PROJECT	TGS Renewal Project	PROJECT #	2808
CLIENT	Trinity Grammar School	DWG #	DA111
DWG	Proposed Site Plan B1	DATE	Feb 2020
CLIENT REF & CONTACT	119 Prospect Rd, Summer Hill	SCALE	1:500 @ A1
ISSUE	DATE	REVISION	CHD
F	11/2/22	Submission for Modification	
E	2/12/21	Revised SSD DCC Part A resubmission	
D	10/12/21	Co-ordination update	
C	16/11/21	SSD DCC Part A resubmission	
B	15/1/21	Seaview building updated	
A	3/2/20	SSDA Submission	
DO NOT SCALE FROM DRAWING. USE FIGURED DIMENSIONS ONLY. CHECK ALL DIMENSIONS ON SITE BEFORE MANUFACTURE OR CONSTRUCTION.			
REVISION	SH	REVISION	SC
			F

PROJECT	TGS Renewal Project	PROJECT #	2808
CLIENT	Trinity Grammar School	DWG #	DA131
DWG	Proposed Performing Arts Precinct & Multipurpose Hall Plan B1	REVISION	E
CLIENT REF & CONTACT	119 Prospect Rd, Summer Hill	DATE	Feb 2020
SCALE	1:200 @ A1	DRAWN	SH
CHECKED	SC

PROJECT	TGS Renewal Project	PROJECT #	2808
CLIENT	Trinity Grammar School	DWG #	DA151
DWG	Proposed Oval 3 Car Park B1	SCALE	200@A1
CLIENT REF & CONTACT	119 Prospect Rd, Summer Hill	DATE	Aug 2021
ARCHITECT	PMDL ARCHITECTURE + DESIGN PTY LTD ABN 56 002 960 357	DRAWN	KC
NSW NOMINATED ARCHITECTS	ANDREW PENDER 5317 DAVID MORRIS 5865 VICKI VAN DIJK 9

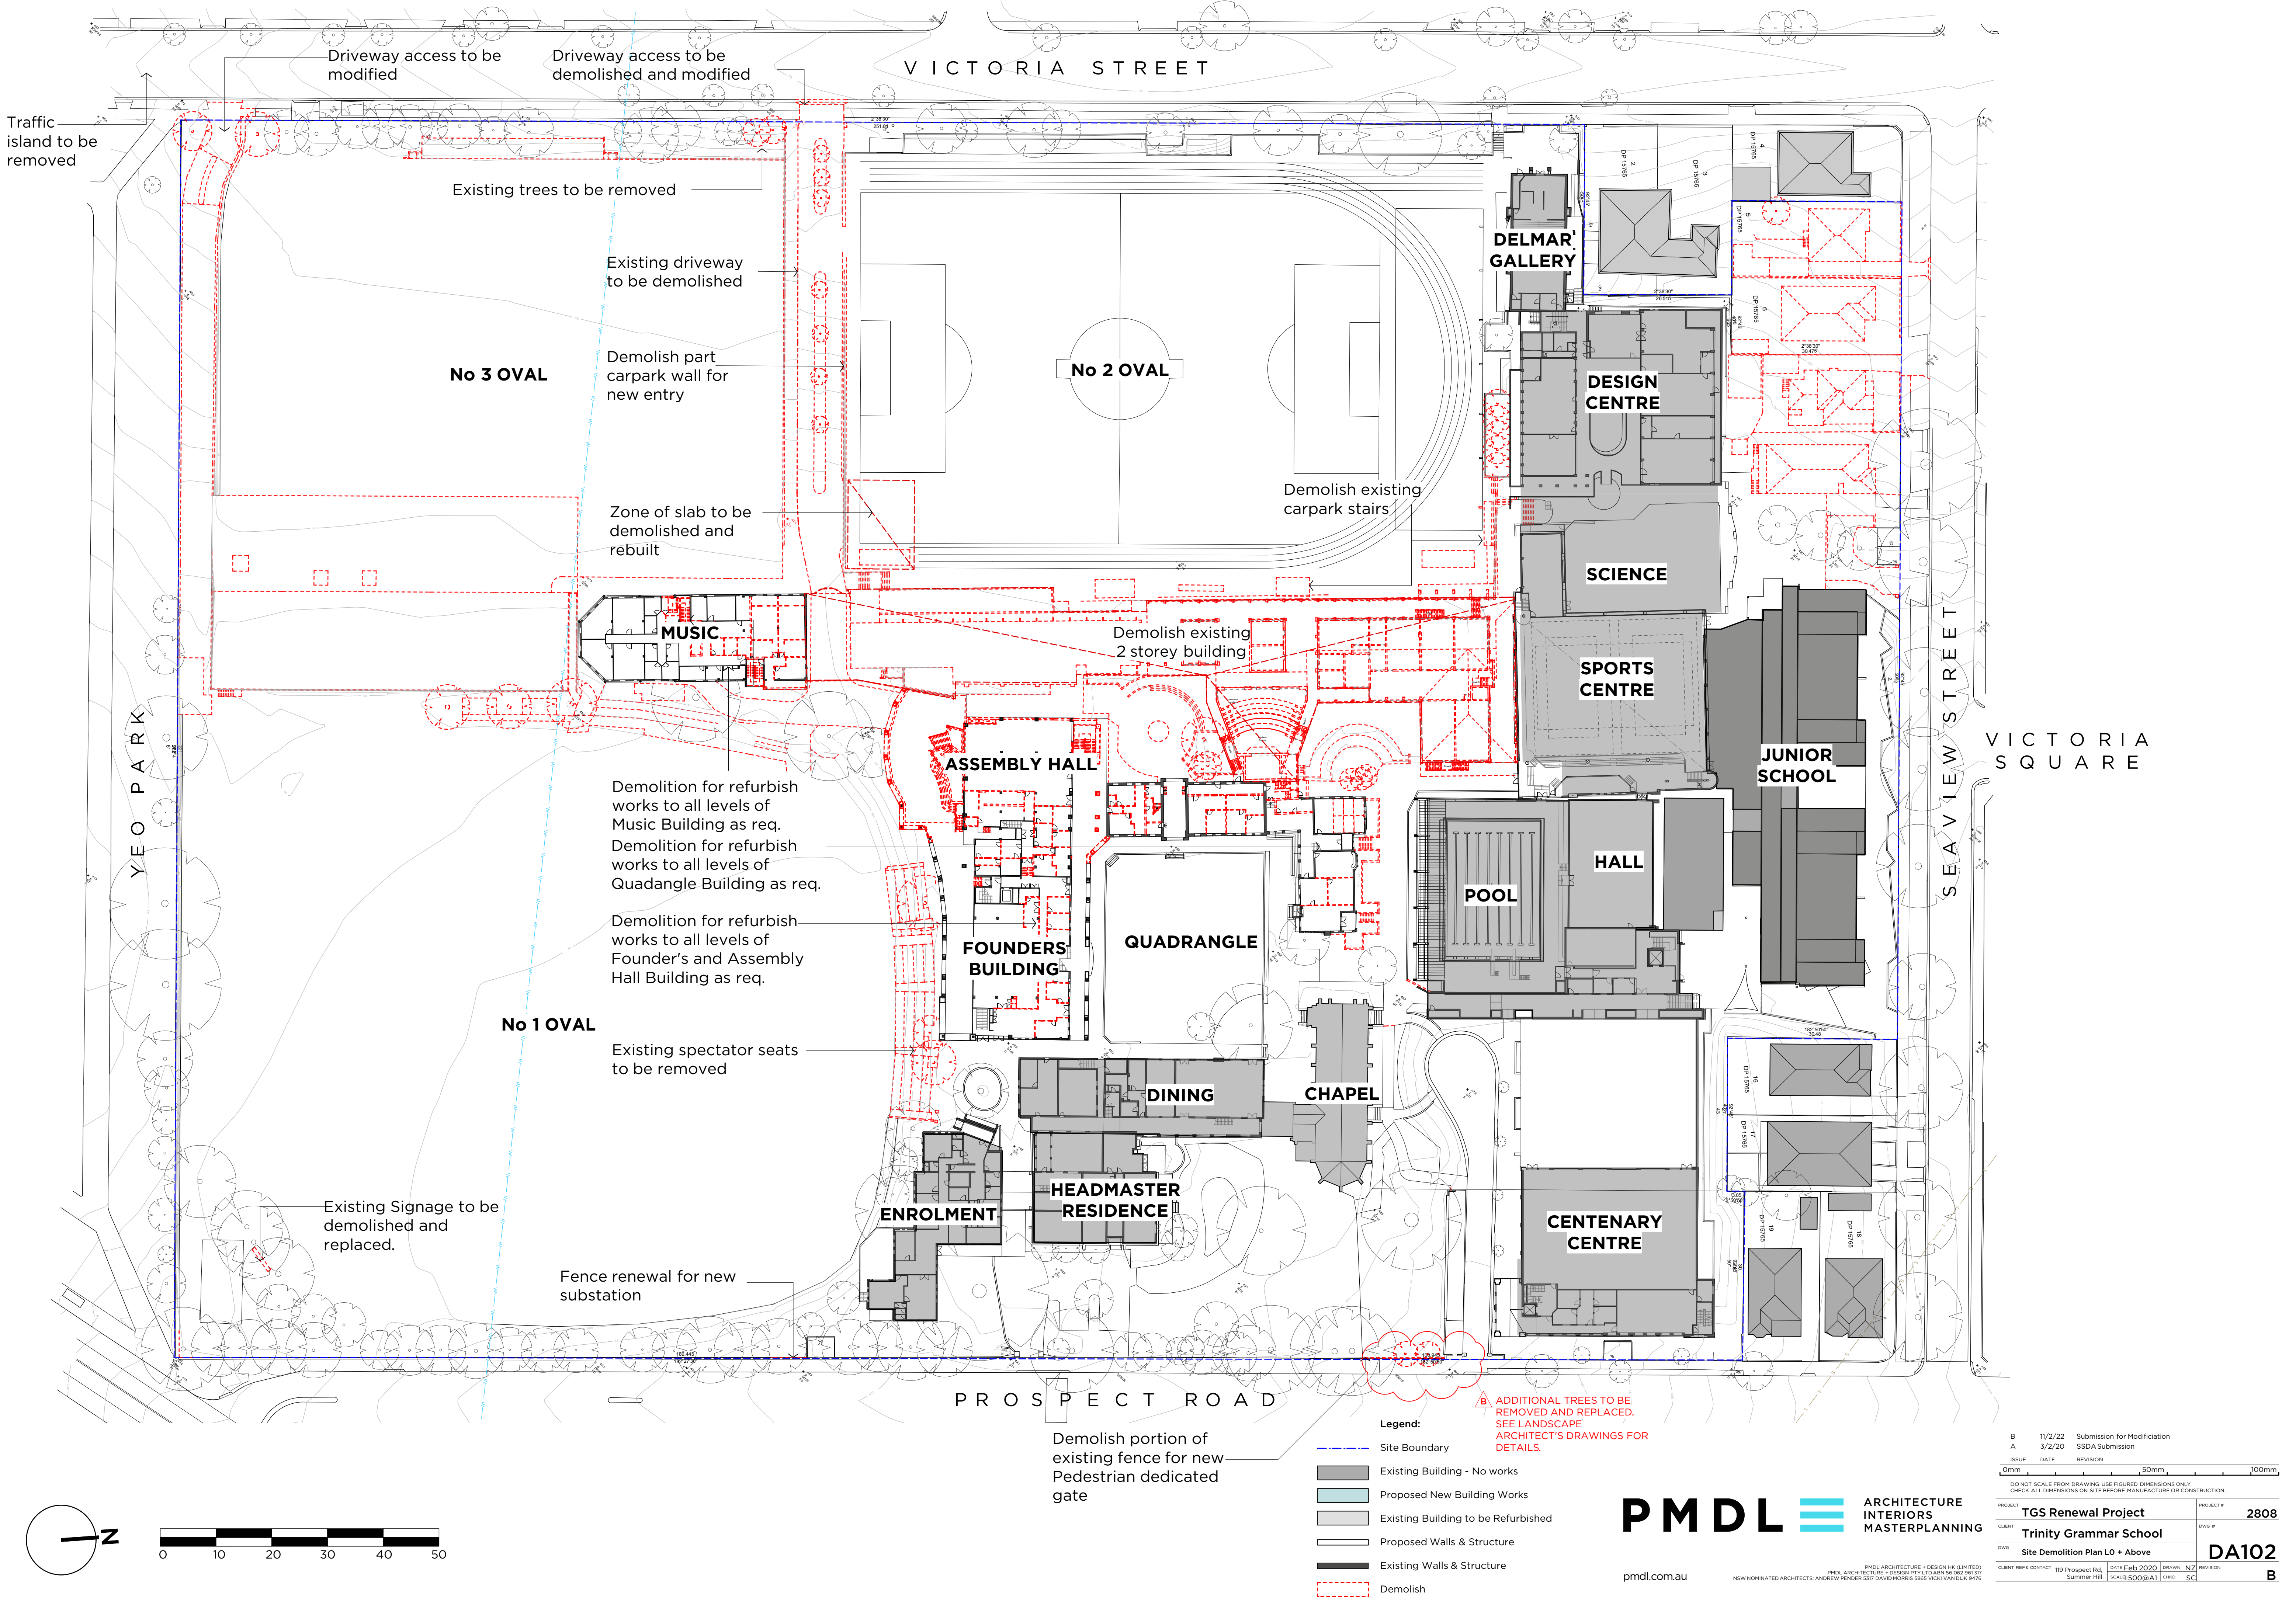
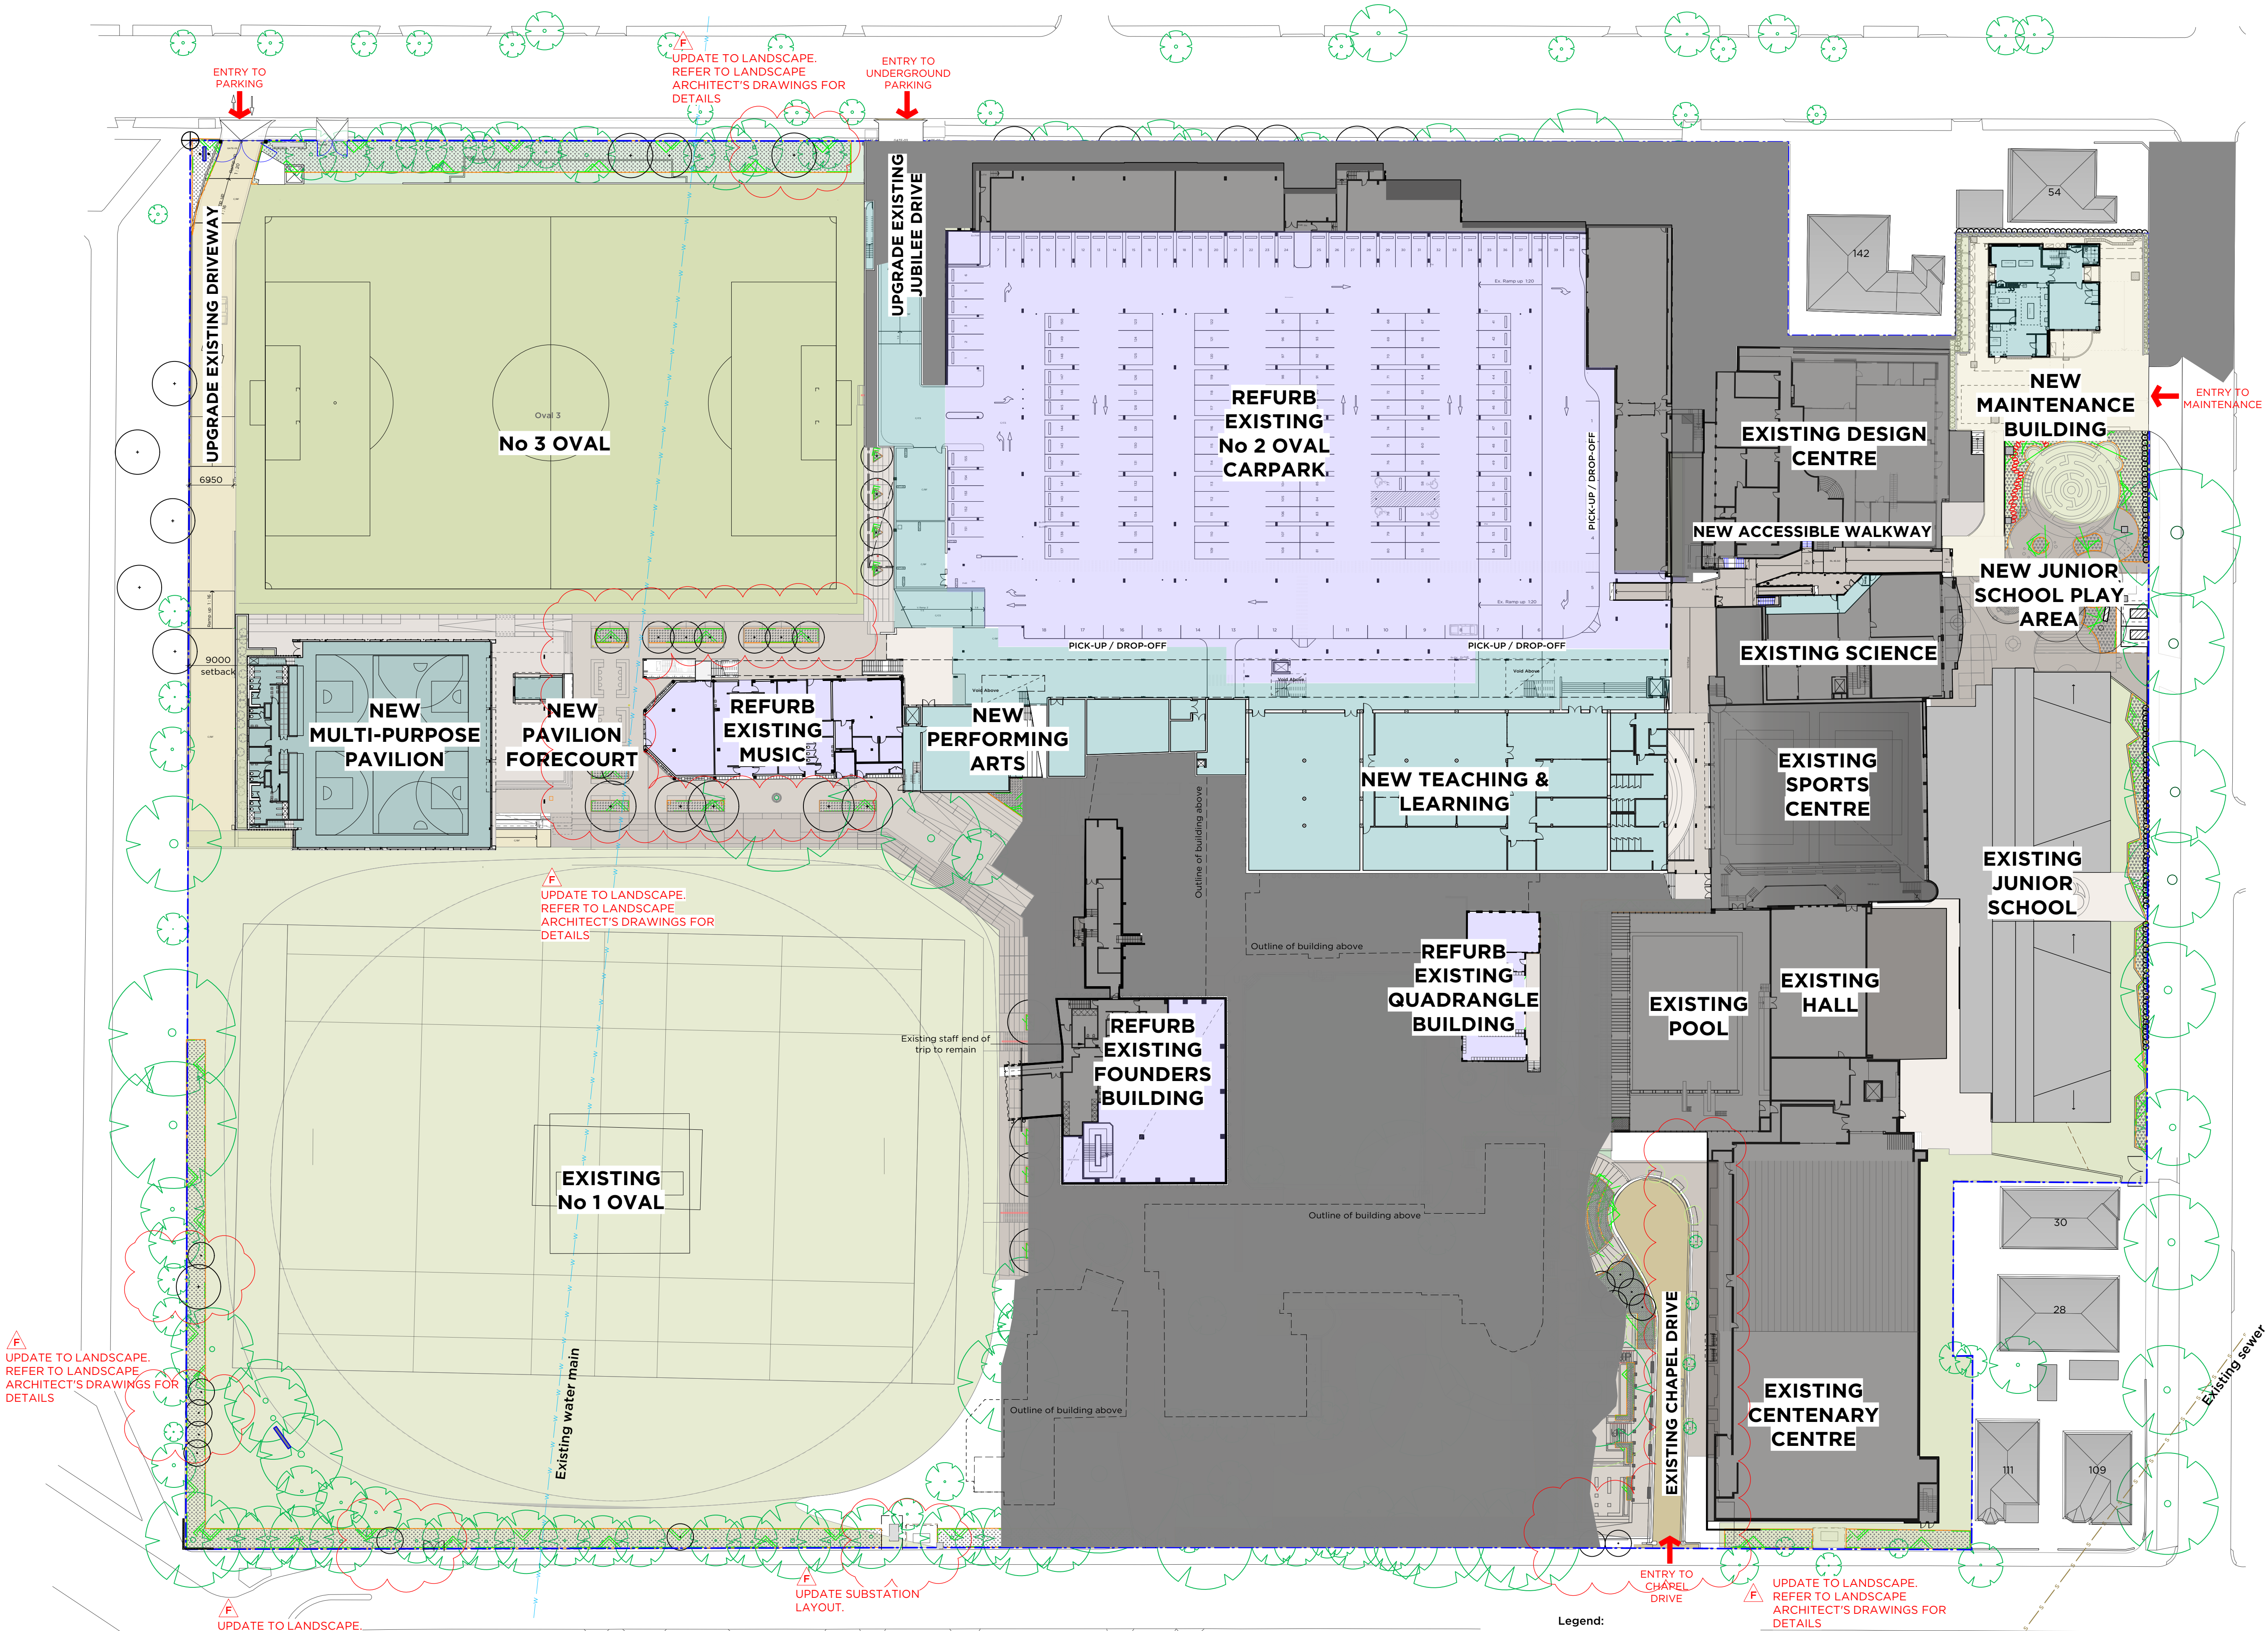
UPDATE TO LANDSCAPE.
REFER TO LANDSCAPE
ARCHITECT'S DRAWINGS FOR
DETAILS

UPDATE TO LANDSCAPE.
REFER TO LANDSCAPE
ARCHITECT'S DRAWINGS FOR
DETAILS

UPDATE TO LANDSCAPE.
REFER TO LANDSCAPE
ARCHITECT'S DRAWINGS FOR
DETAILS

UPDATE SUBSTATION
LAYOUT.

UPDATE TO LANDSCAPE.
REFER TO LANDSCAPE
ARCHITECT'S DRAWINGS FOR
DETAILS
